STATE OF CONNECTICUT
CONNECTICUT SITING COUNCIL

RE: **PETITION NO. 1385** – Cobb Road, LLC declaratory ruling, pursuant to Connecticut General Statutes §4-176 and §16-50k, for the proposed construction, maintenance and operation of a 1.95-megawatt AC solar photovoltaic electric generating facility on approximately 11.16 acres located at 20-1 Short Hills Road, Old Lyme, Connecticut and associated electrical interconnection. **Partial Development and Management Plan.**

Petition No. 1385
Cobb Road LLC
Partial Development & Management Plan
20-1 Short Hills Road, Old Lyme
Staff Report
March 11, 2021

Site Layout – Sheet 1 of 2

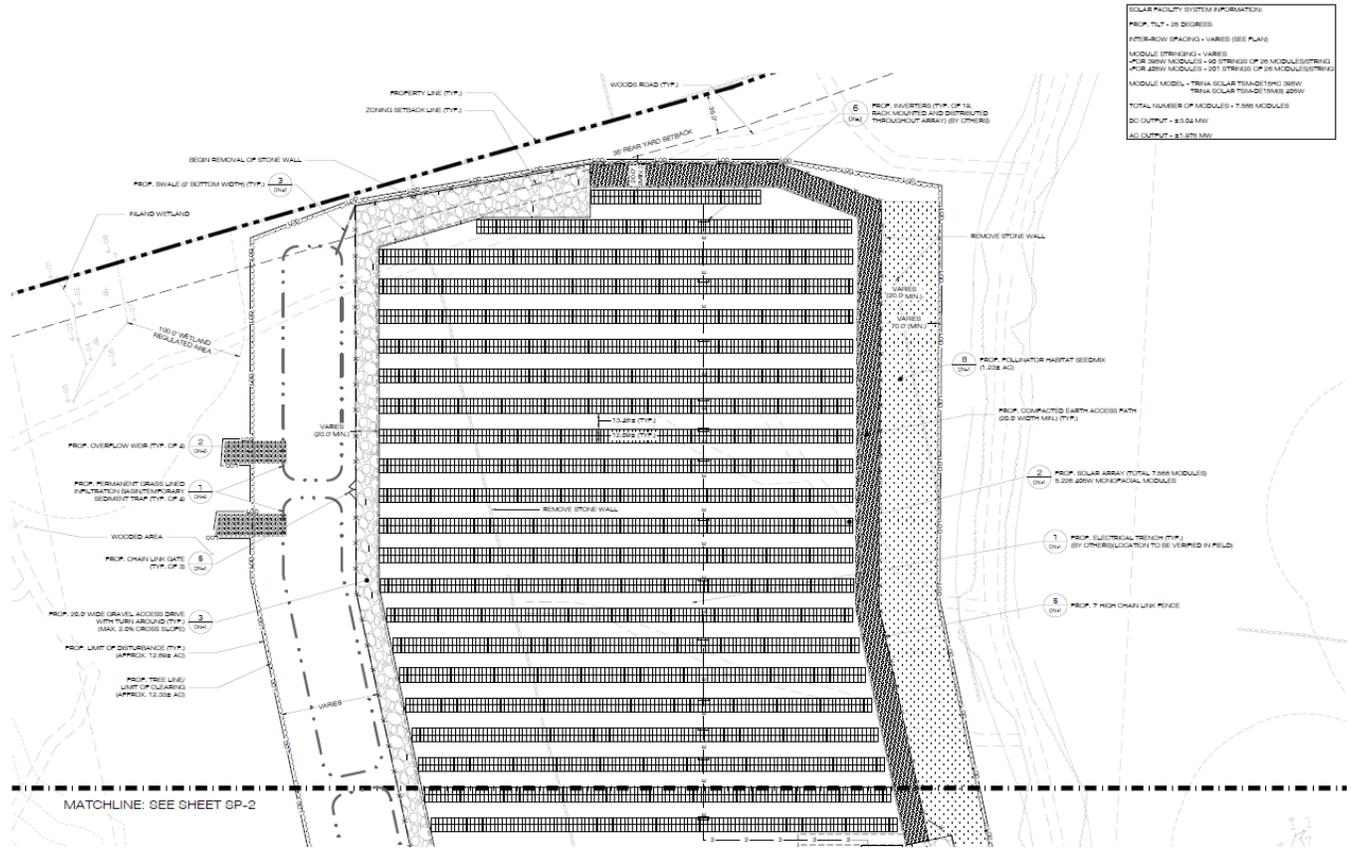
The final site plans illustrate the site design, solar array arrangement, access roads, electrical interconnection route, perimeter fencing, and equipment pads.

The site design was modified by reducing the total number of solar panels from 7,704 to 7,566. The original configuration consisted of 7,704 panels of 390 Watts each. In Partial D&M Plan II, the configuration is 2,340 bifacial panels of 395 Watts each and 5,226 monofacial panels of 405 Watts each. Thus, the inclusion of higher wattage panels allows for a net reduction in panel quantity while keeping the total DC MW approximately the same at 3 MW. The AC capacity will increase slightly to 1.975 MW.

A 30-foot by 15-foot concrete equipment pad will be located in the eastern portion of the fenced facility.

CR has included its electrical interconnection route which will run underground from the equipment pad to reach a new riser pole to the east. A total of six new poles (including the riser pole) will be installed to facilitate the interconnection of the solar facility to existing overhead Eversource electrical distribution located in the ROW directly southeast of the solar array area.
